Proposal #18: 2090-03-71, WISC 2019159
E Silver Spring Dr
Intersection With Bay Ridge Ave
Local Street
Milwaukee County

This is Addendum No. 02, which provides for the following:

ADDENDUM NO. 01

2090-03-71

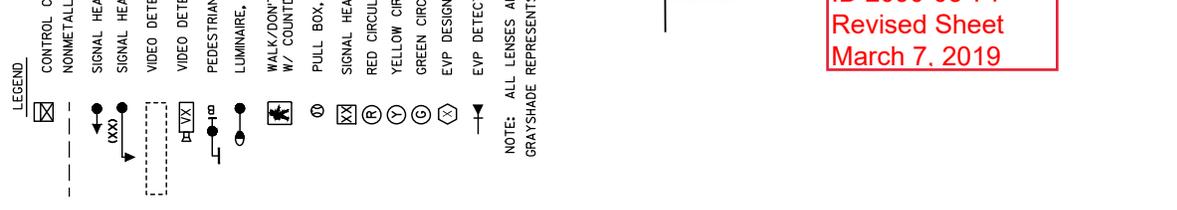
Revised Plan Sheets	
Plan Sheet	Plan Sheet Title (brief description of changes to sheet)
10	Traffic Signal Plan – revised locations for relocated twin arm luminaires
13	Cable Routing – revised routing of Lighting UF 12 AWG W/Ground
33	Miscellaneous Quantities – revised quantity for 655.0320
